Re: 1376 Campus Road  
Final Subdivision and Land Development Plan – Phase 3  
Township Permit No. 25-05-FLDP  
LCEC Project No: 25-100

PROJECT TITLE  
1376 CAMPUS ROAD - PHASE 3  
FINAL SUBDIVISION &  
LAND DEVELOPMENT PLAN  
MOUNT JOY TOWNSHIP  
LANCASTER COUNTY, PA

Re: Final Subdivision & Land Development Plan for 1376 Campus Road – Phase 3  
Our File No. 10221-1

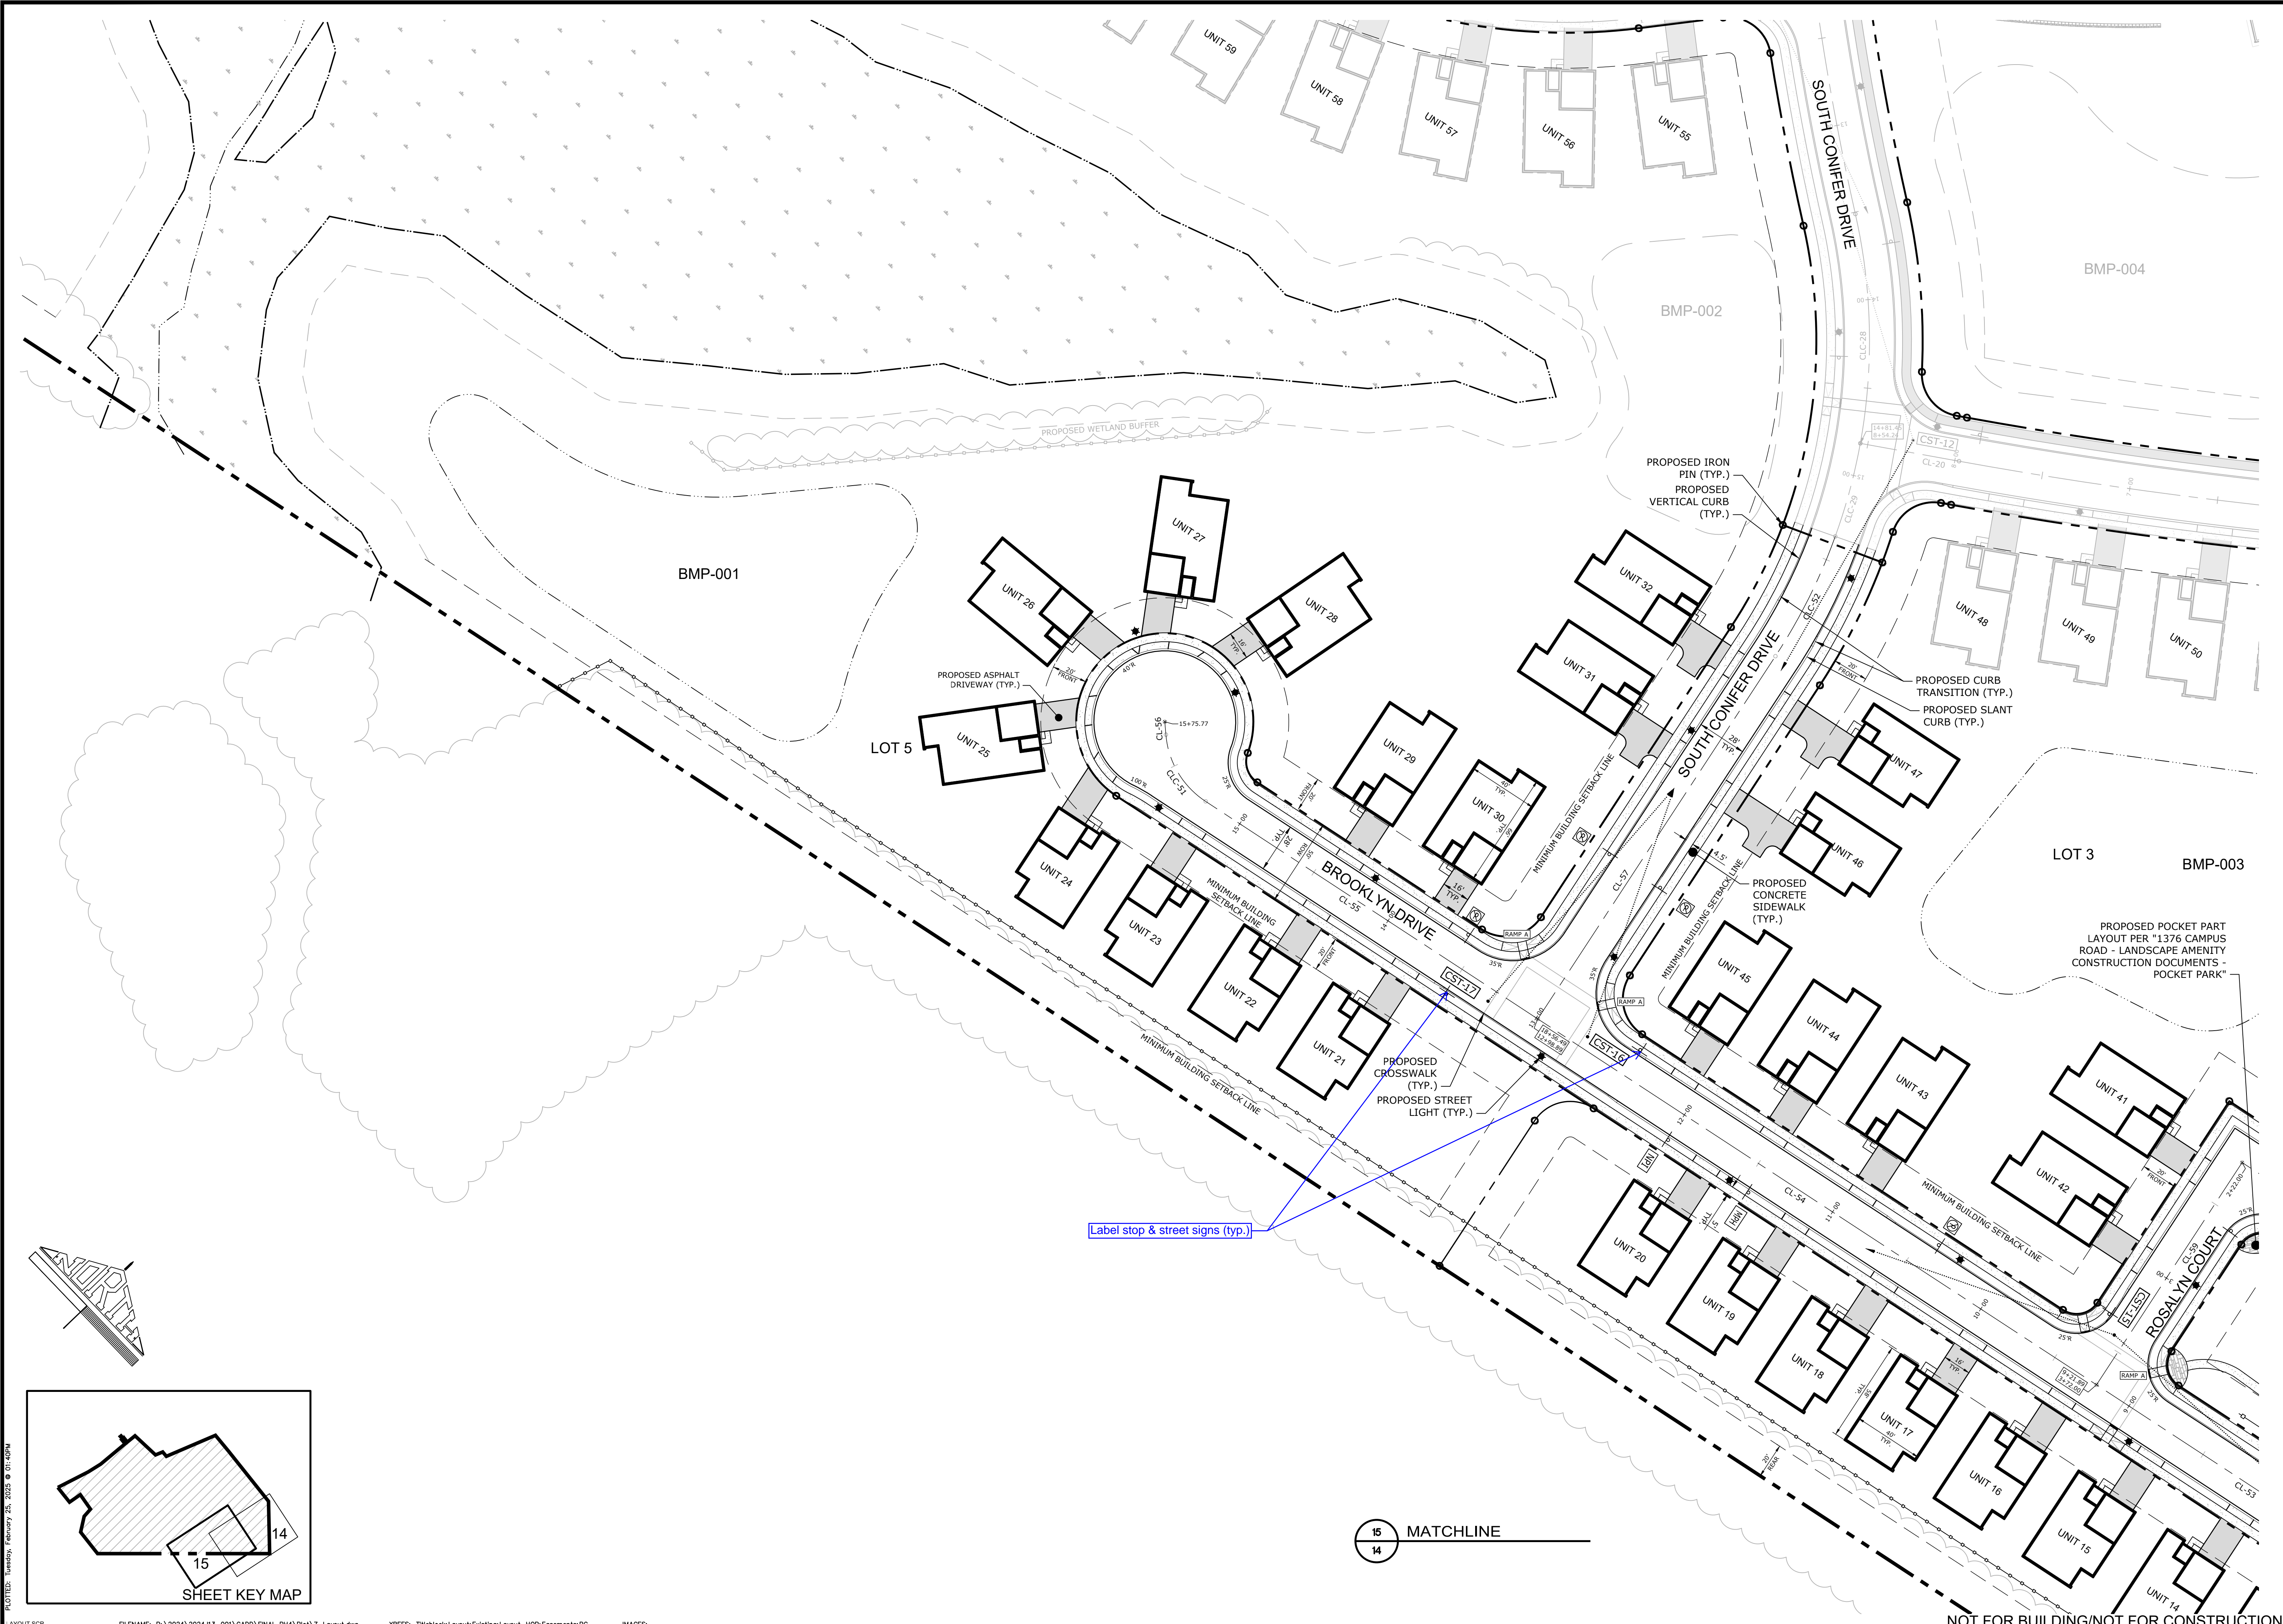
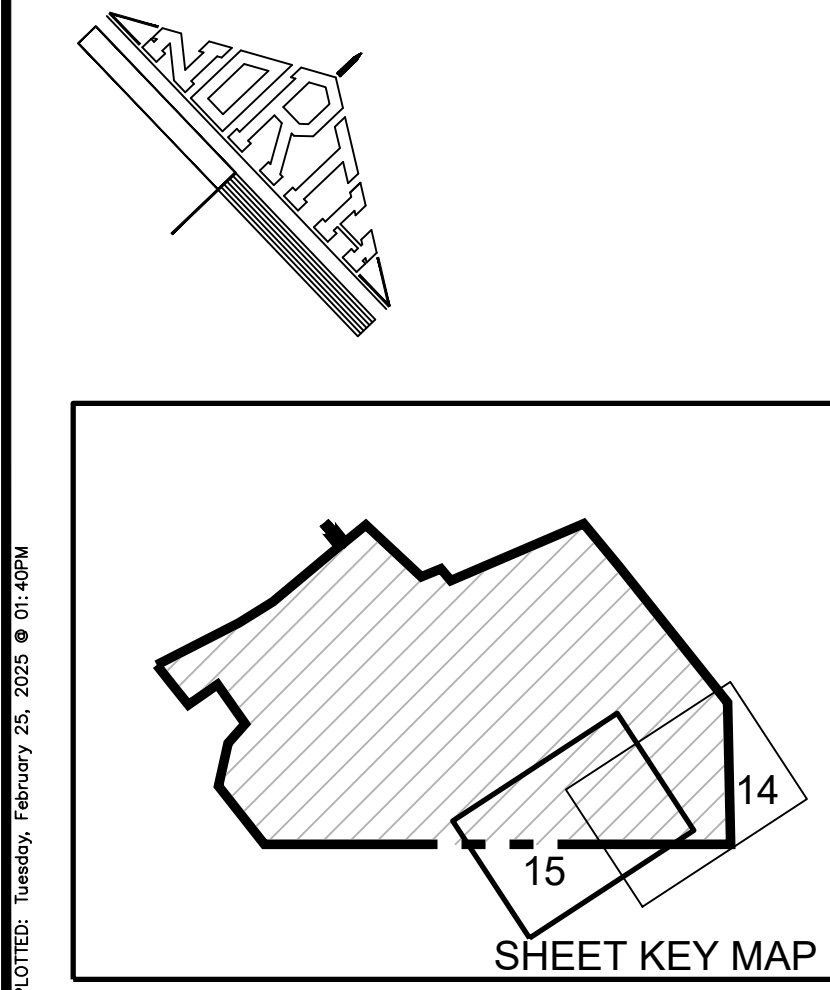
Sheets 14 and 15 of the Phase 3 Plan show an improvement along the tree line at the rear of units 12 through 24 and BMP-001. There is no legend for this item. Is it a permanent or temporary construction fence? If it is a permanent fence, it is located within swales 1 and 2.

LANDSCAPE PLAN

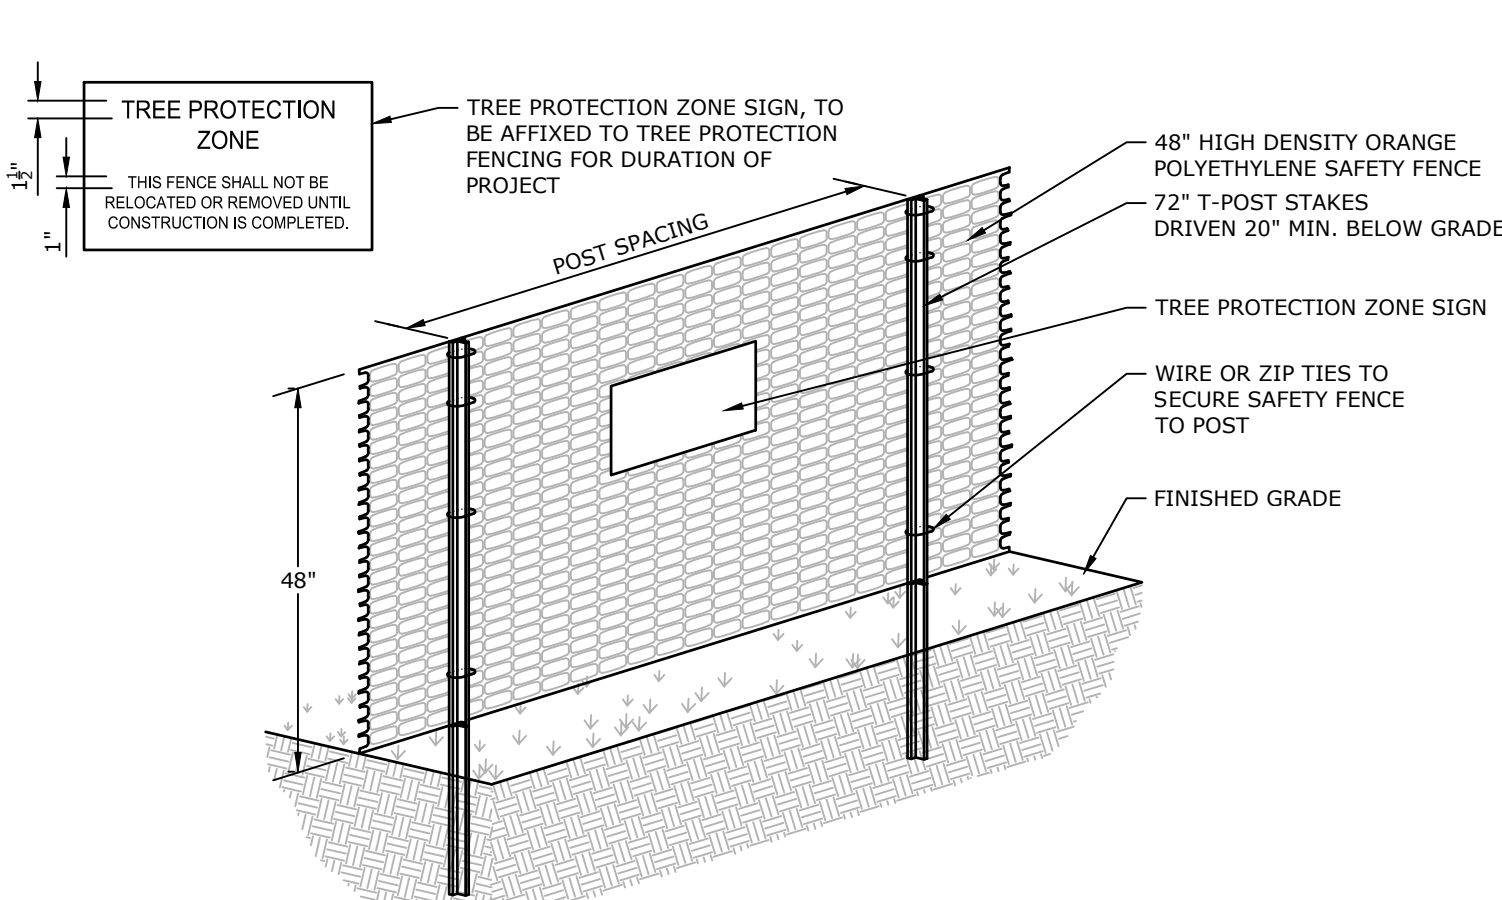
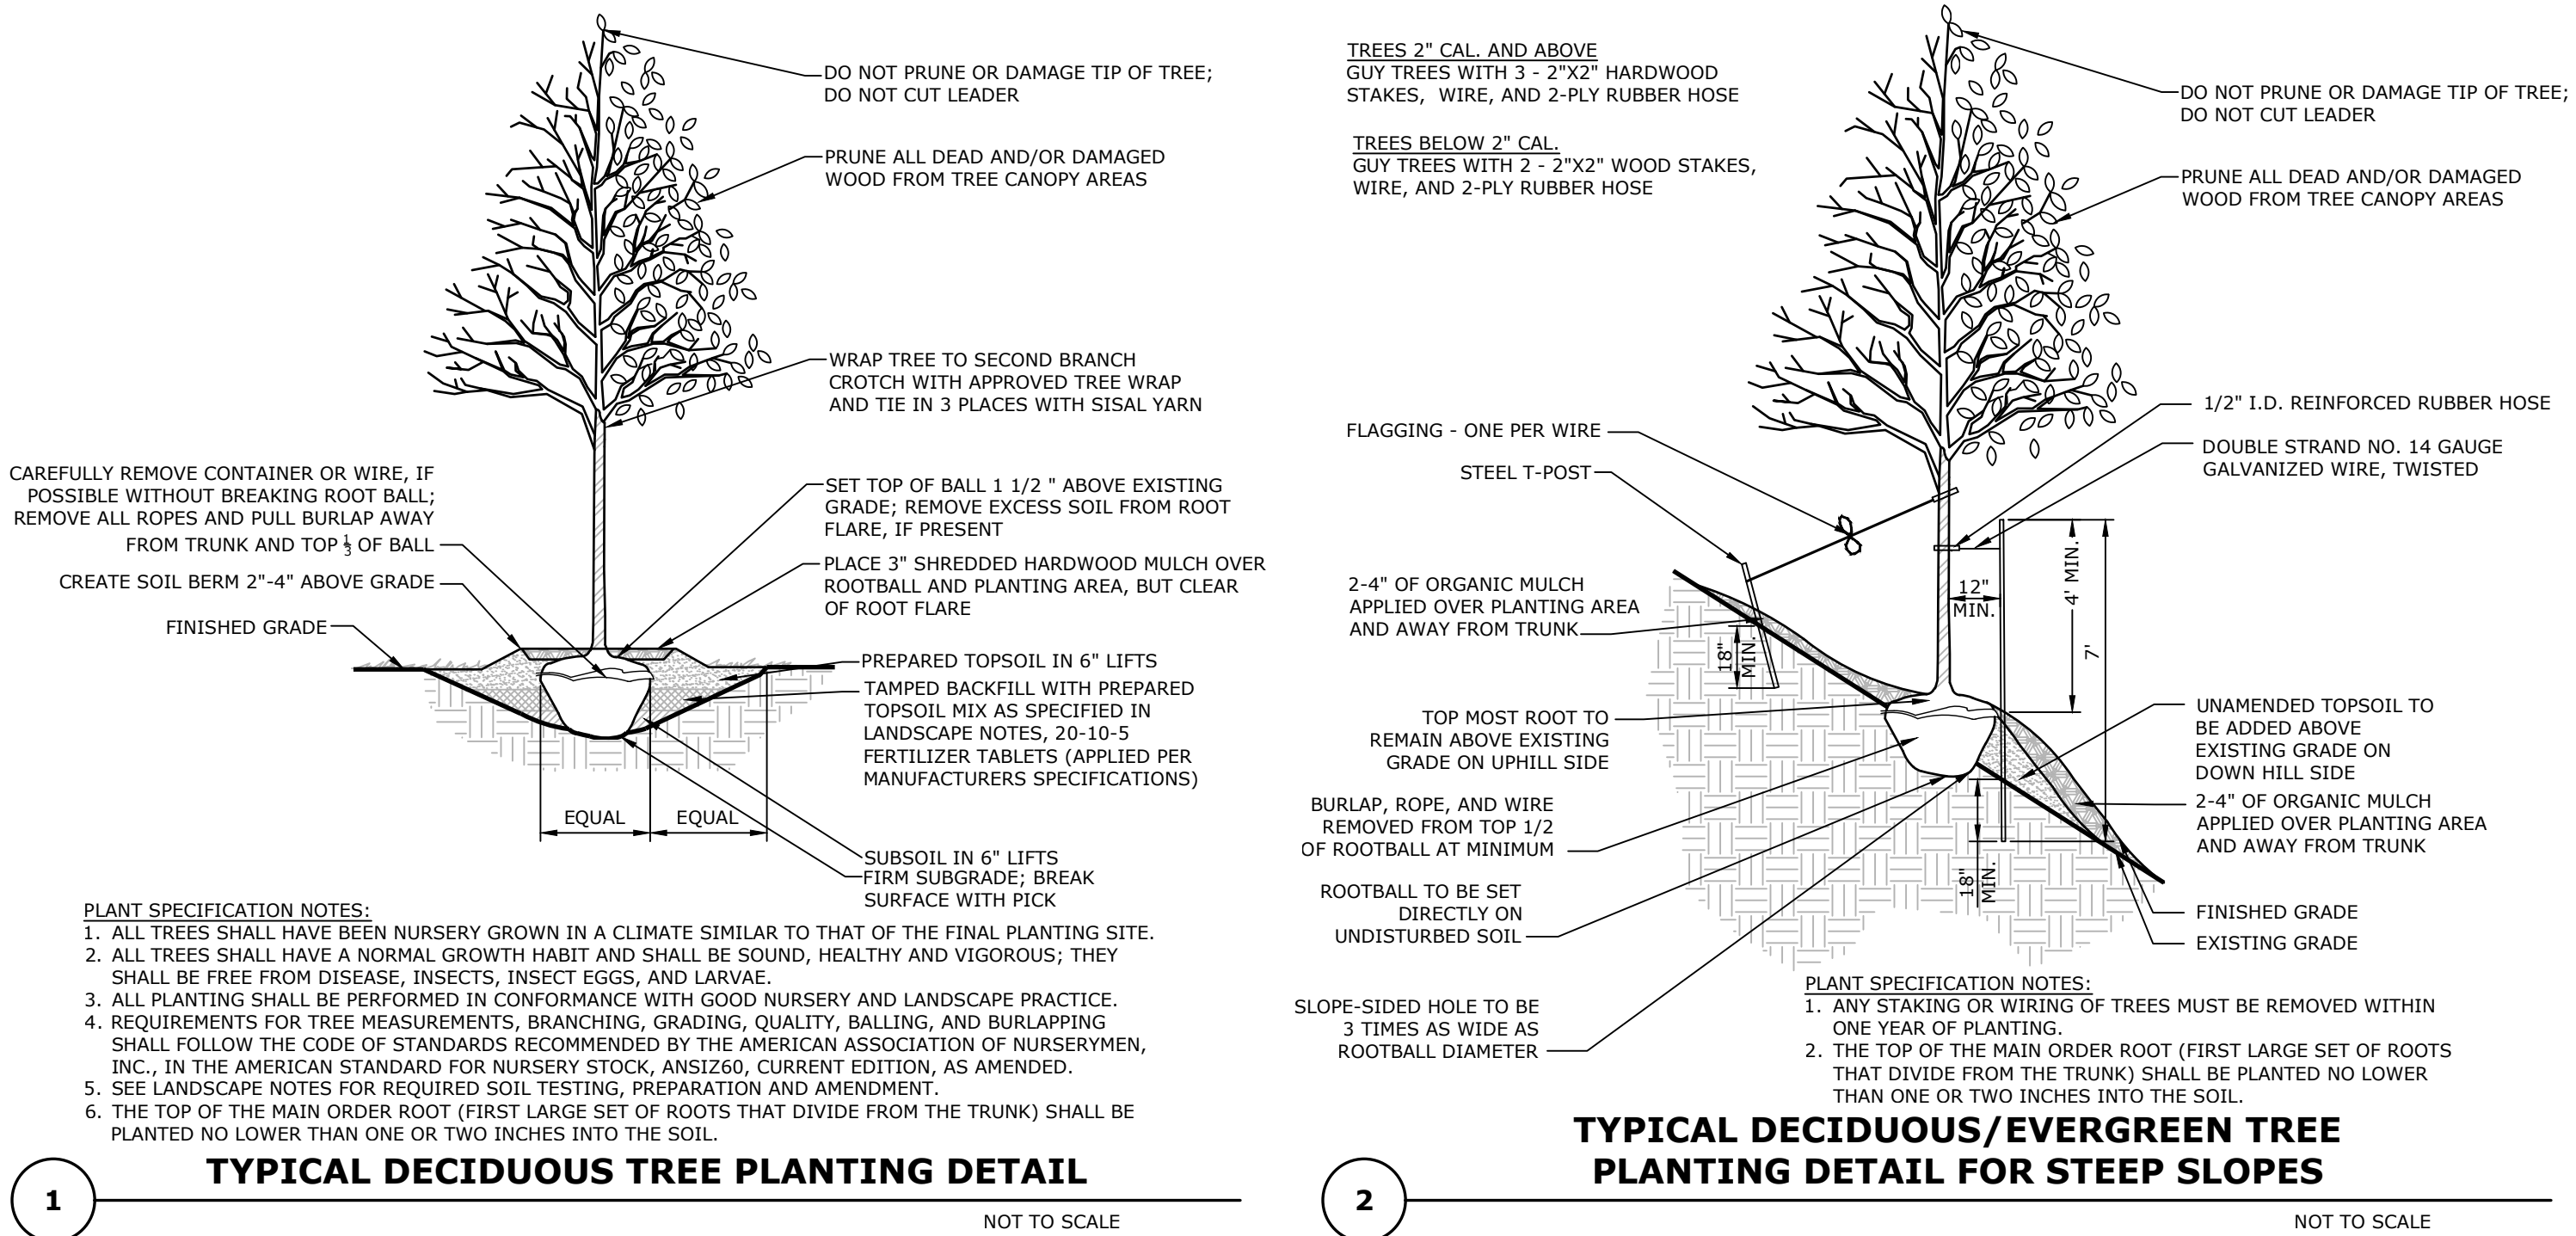
Provide plug planting information for BMP-001 and BMP-003
